**TOWN OF HERNDON, VIRGINIA
PLANNING COMMISSION PUBLIC HEARING AGENDA
FEBRUARY 25, 2019
HERNDON COUNCIL CHAMBERS BUILDING
765 LYNN STREET
7:00 P.M.**

Subject: Development Plan Application, DP#17-01, 555 Herndon Parkway

This memo serves as an addendum to the Planning Commission staff report, dated February 11, 2019, which was considered by the Planning Commission in its review of the above referenced case at its February 11, 2019 work session. The applicant has since submitted revised application materials to address the issues raised by staff and the Planning Commission.

Development Plan

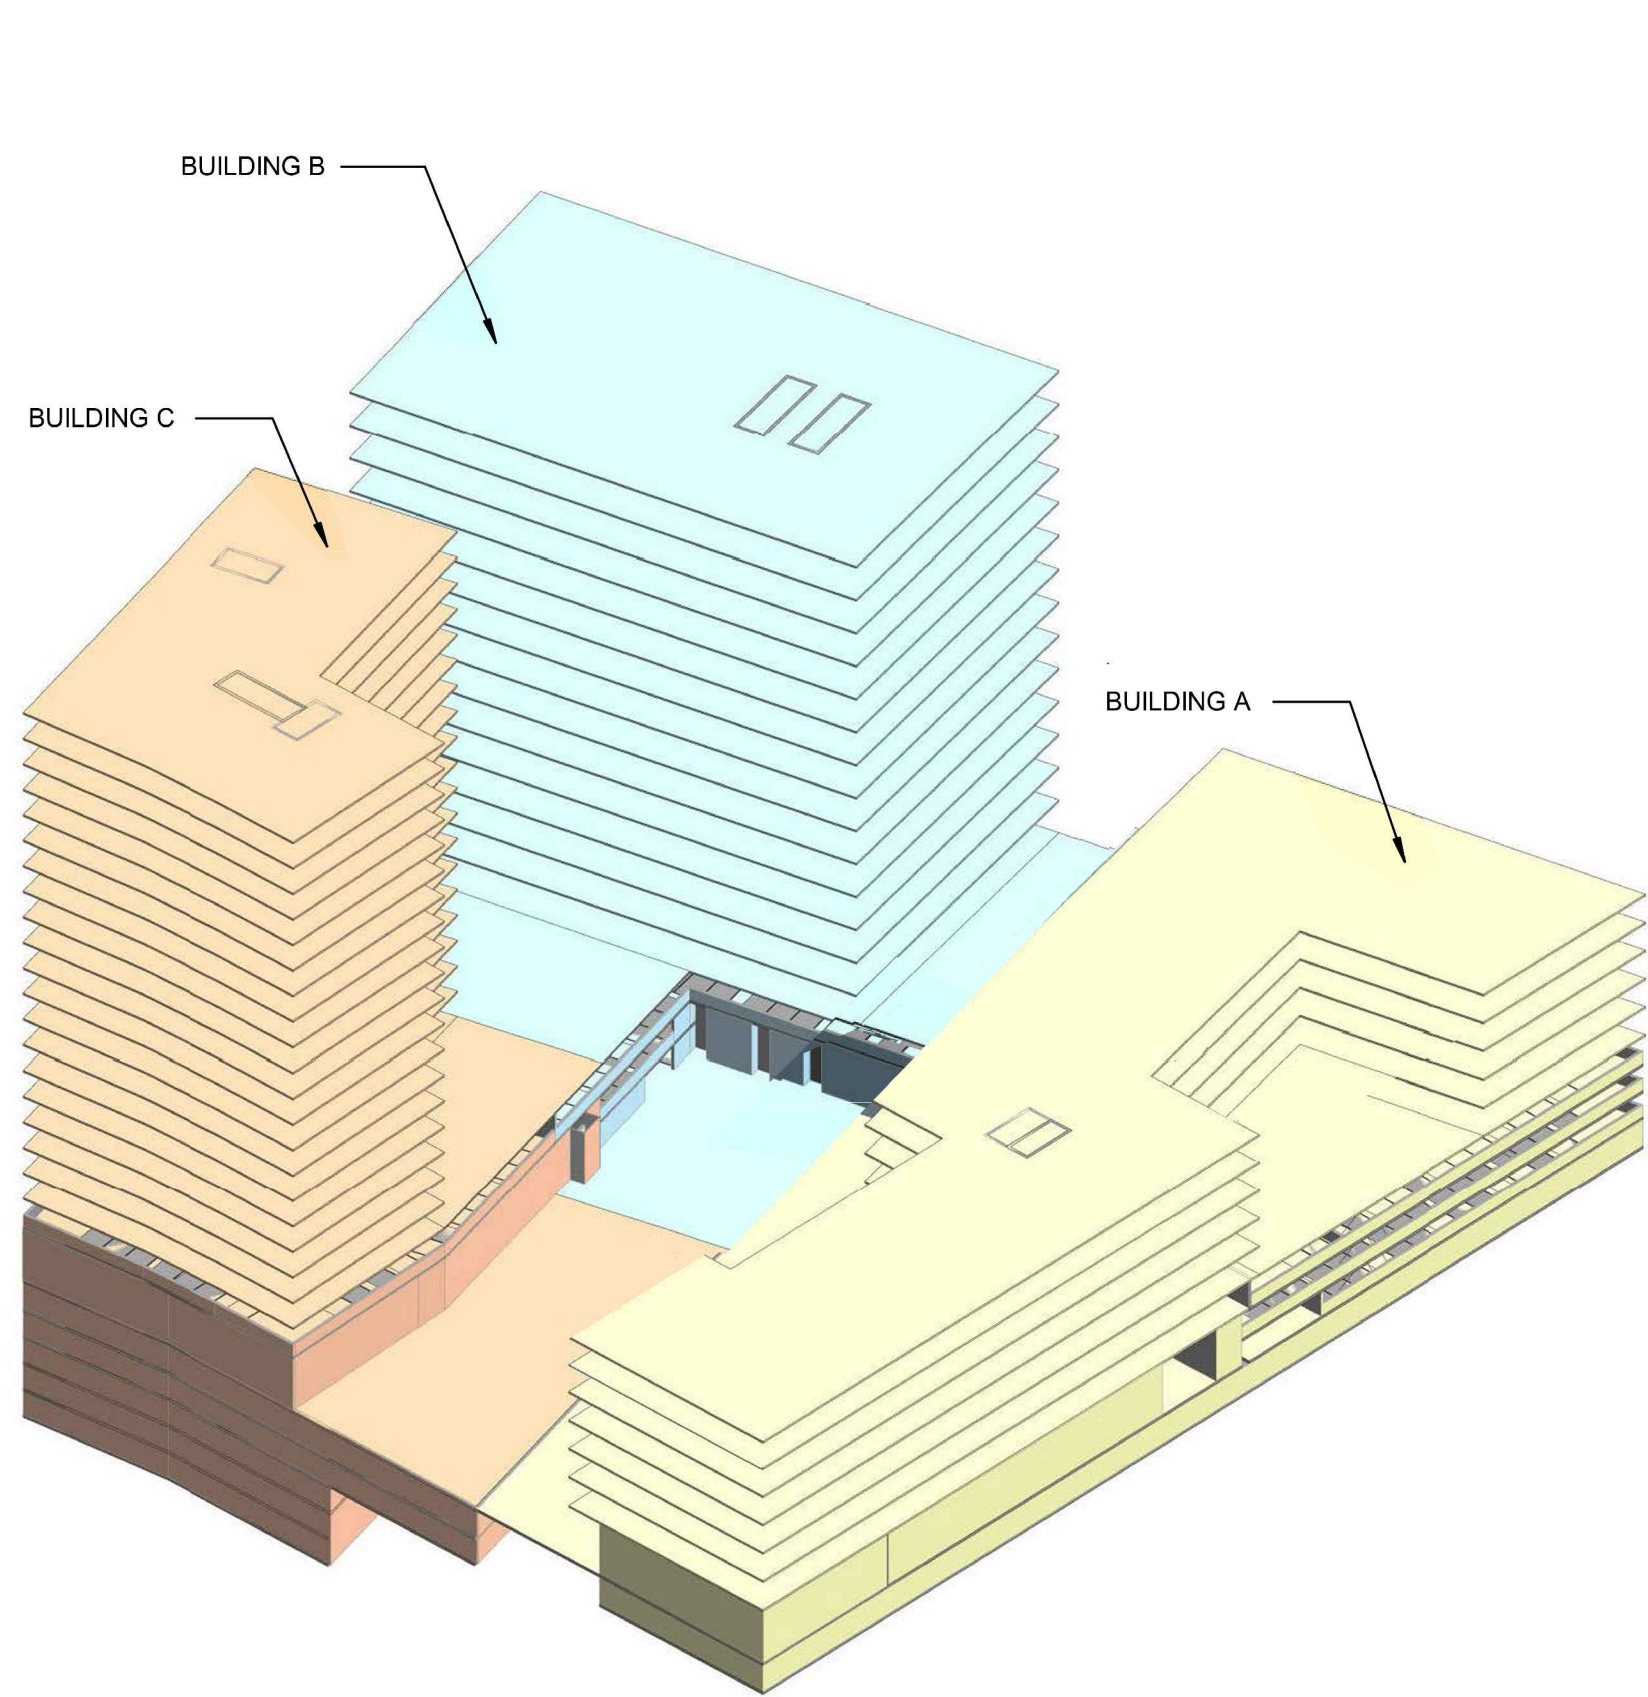
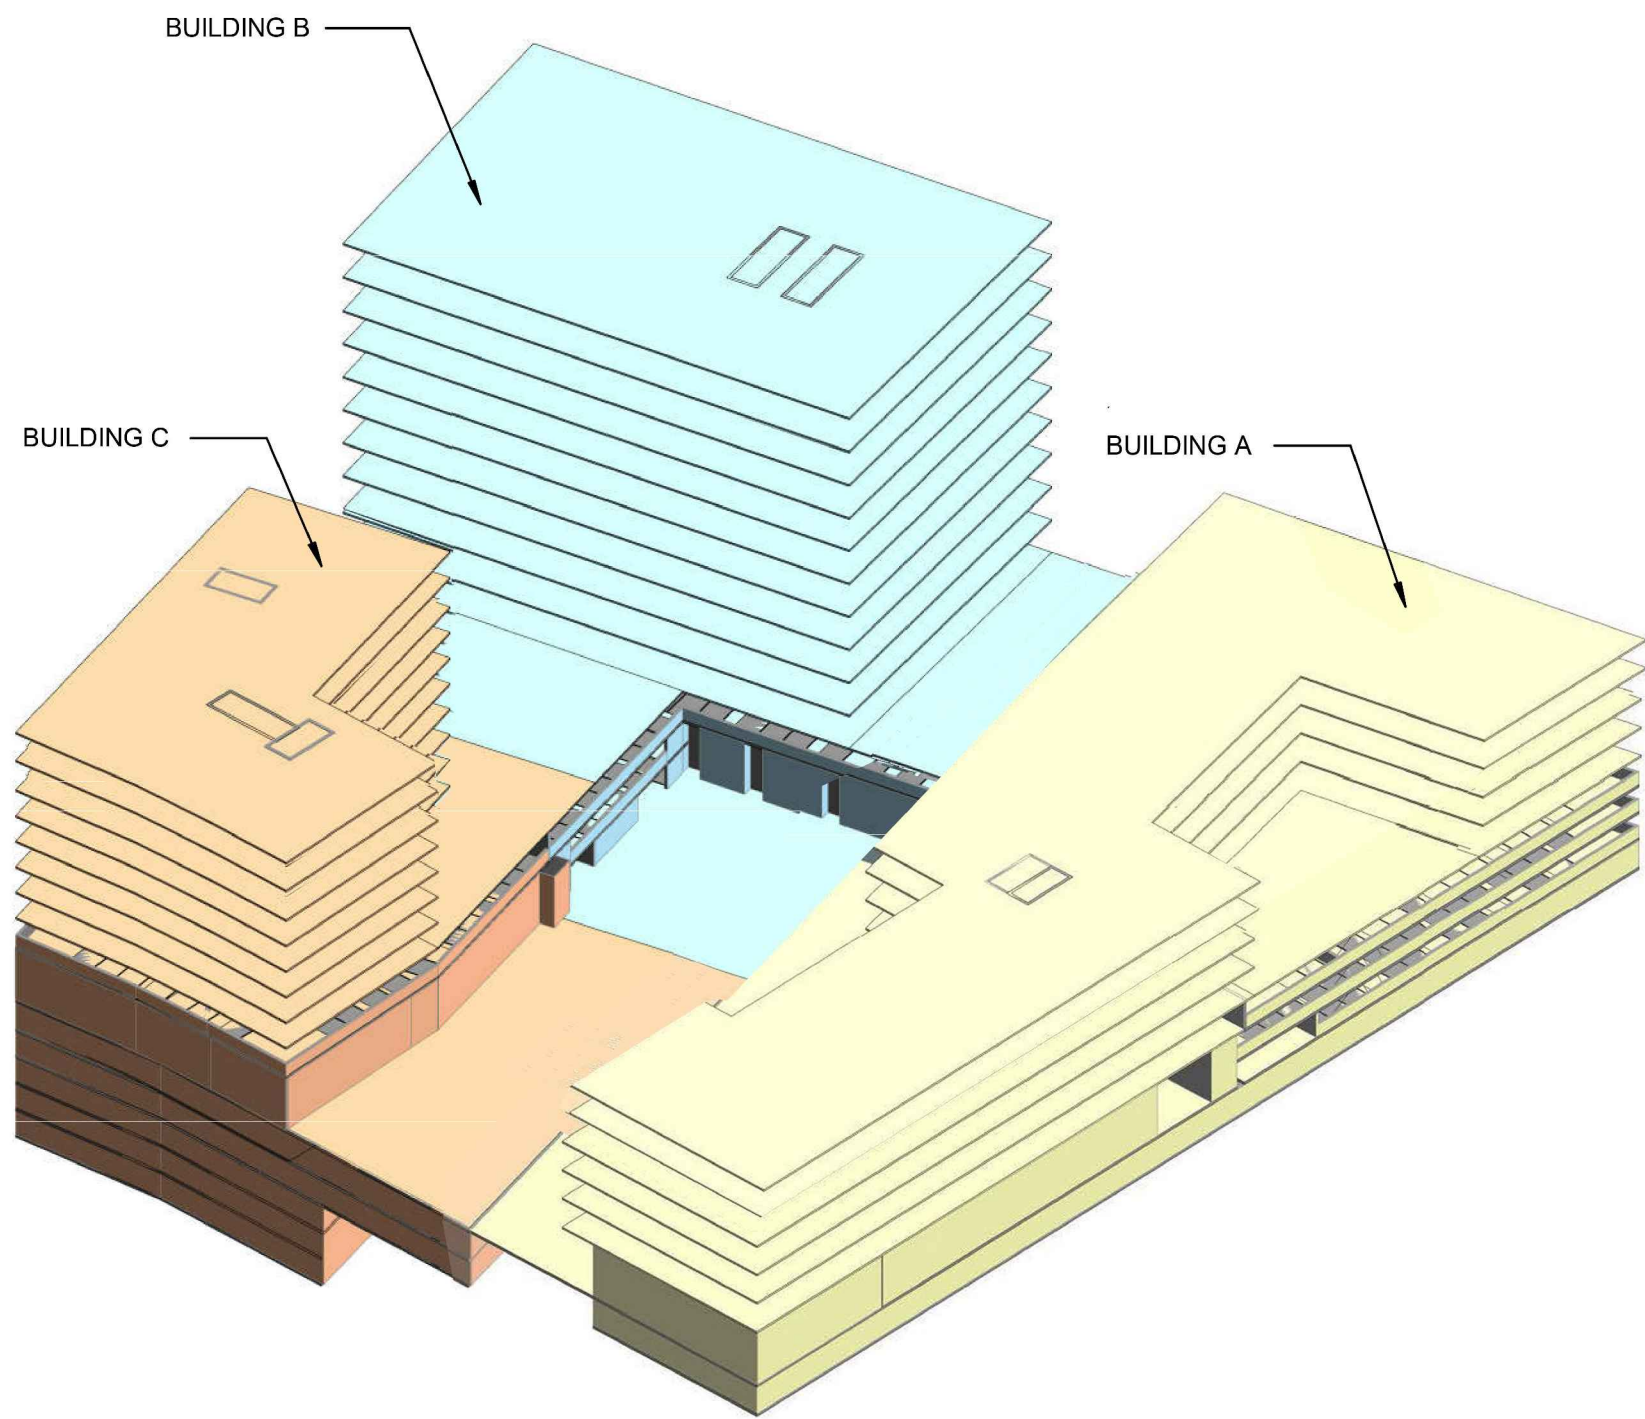
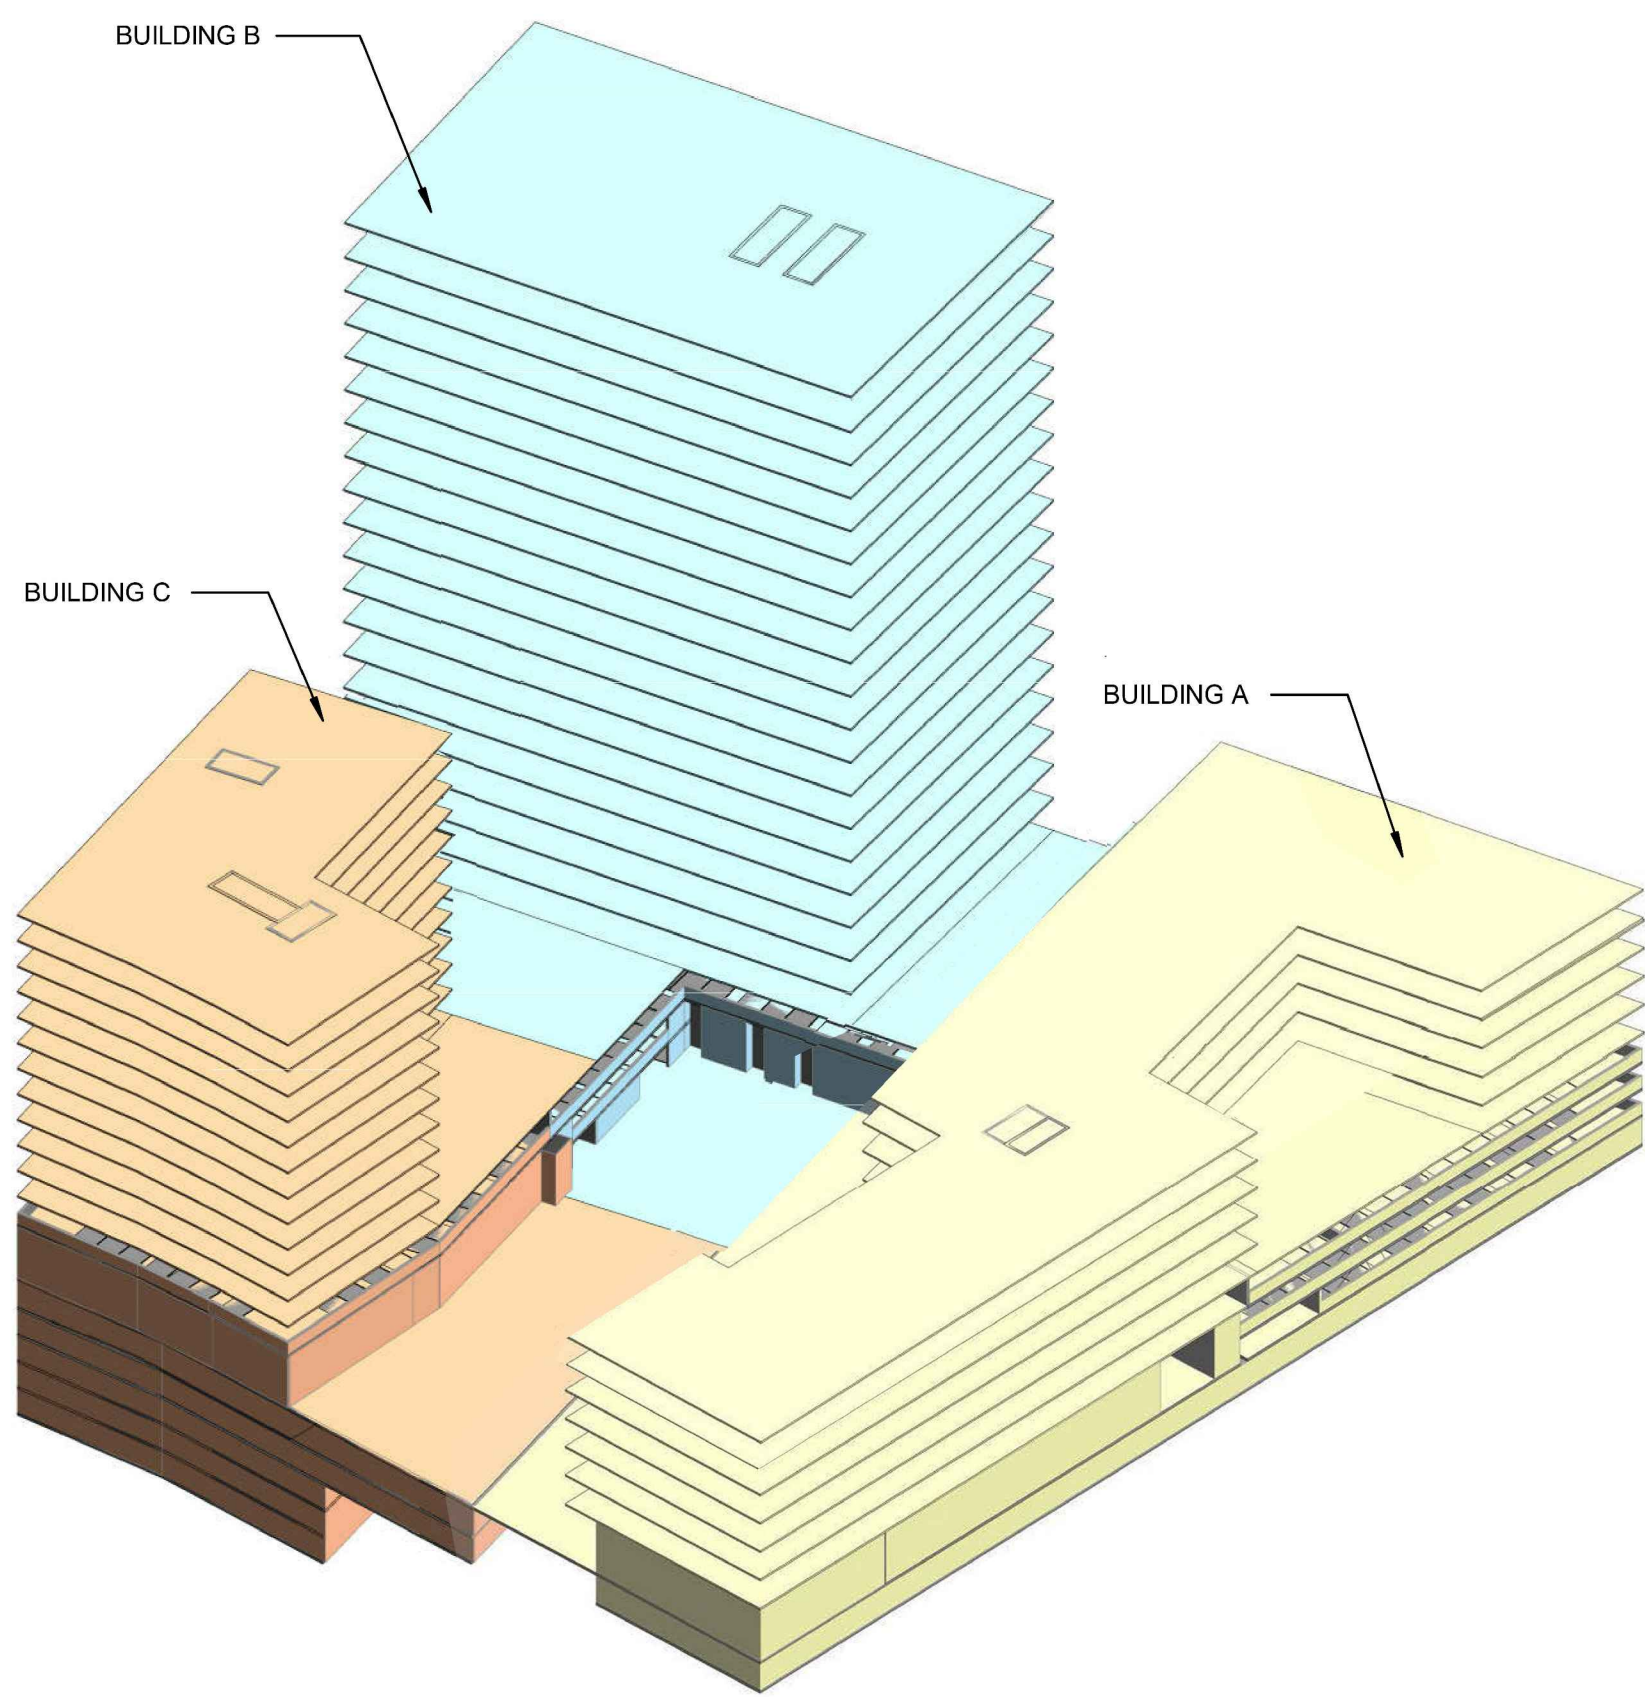
- The massing diagrams on Sheet 4.0 has been revised to illustrate a range of massing scenarios. Two massing models have been added; one showing the massing of all buildings if built to the lowest levels and one showing the massing of Building B if built at the maximum 275' height.
- The development tabulations table on Sheet 4.0 has been revised to remove the previous proposal to include interim retail and to adjust some of the maximum and minimum building heights. All proposed building heights continue to meet zoning ordinance regulations.
- On Sheet 4.0, the notes referencing the interim retail and allowance for parking adjustments have been removed.
- In the phasing plan showing only Building A, the internal street is fully designed (with decorative pavers) up to its eastern edge (Sheet 5.1). Previously it was shown in an interim asphalt condition.
